MEMORANDUM

From: Chief Officer, Environment & Technical **To:** Chief Officer Planning & Regulatory
Our Ref: P/2020/0623 **Your Ref:** P/2020/0623
Date: 3 November 2020

**ERECTION OF FOODSTORE (USE CLASS A1), CAR PARK, ACCESS AND LANDSCAPING.
CODI STORFA FWYD (DEFNYDD O DIR A1), MAES PARCIO, MYNEDIAD A THIRLUNIO
LAND AT HOME FARM GRESFORD ROAD LLAY WREXHAM**

Wrexham Council Highway Comments

Figure 1 Extract of Drawing 486-01/GA- 11 Rev A – Left-turn only entrance Straight Mile

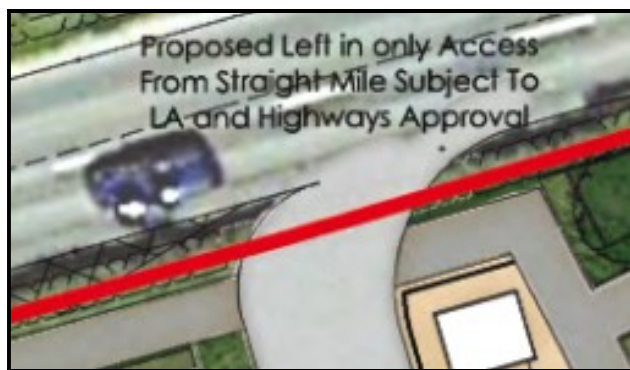
A left-turn only vehicle entrance is proposed on the Straight Mile. The proposed vehicle entrance appears to be of a non-standard geometry and there are concerns regarding how such an arrangement will be constructed. Since the highway layout drawing (Drawing 486-01/GA- 11 Rev A) provided is preliminary there is not enough information for Wrexham Council Highways Team to be satisfied that the proposed left-turn only entrance is appropriate and safe, illustrated in Figure 1 below.

The proposed kerb alignment on the western side of the proposed access could be a hazard and could be hit by turning vehicles. The applicant / agent is required to demonstrate that the access is suitable by evidencing the design standards used to design the proposed left-turn only entrance. The geometric layout of new accesses on existing roads should be designed in accordance with current design standards and should be related to the design speed of the major road and the size of the vehicles using the access. The applicant / agent should therefore also provide vehicle tracking to demonstrate that larger vehicles can access the site from the Straight Mile, since it appears no vehicle type restrictions are proposed.

Figure 2 Extract of Drawing 486-01/GA- 11 Rev A – Internal carpark layout at left-turn only access

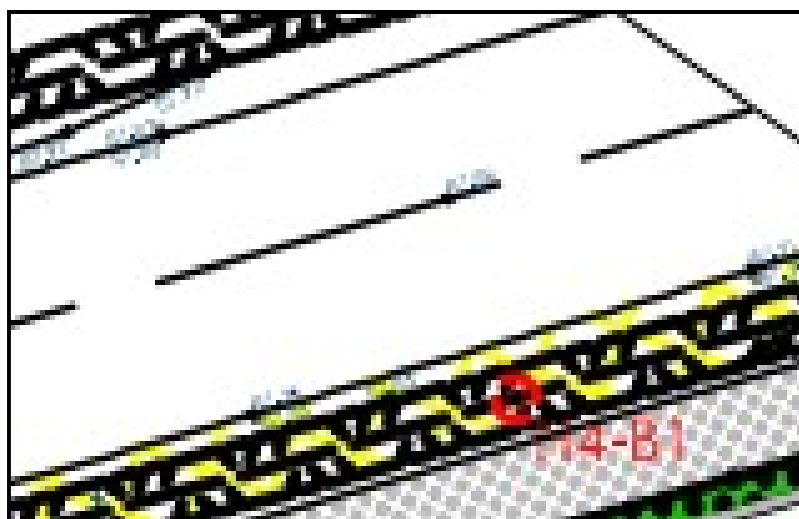
The stage 1 RSA identified a potential for conflict at the proposed site entrance off the Straight Mile due to the car park being very close to the access. The audit team recommended that the internal layout of the car park is amended so turning traffic does not have to give-way to internally circulating car park traffic. The designer has accepted the problem and amended Drawing 485-01/GA-11 (now Rev A) to show priority amendments within the car park, by the addition of a give-way road marking (Figure 2). Wrexham Council Highways Team feel that it would be beneficial to make the section of car park close to the entry point a dead end in order to ensure vehicles do not circulate the carpark in the direction of vehicles entering the site. This could be reviewed on site following construction.
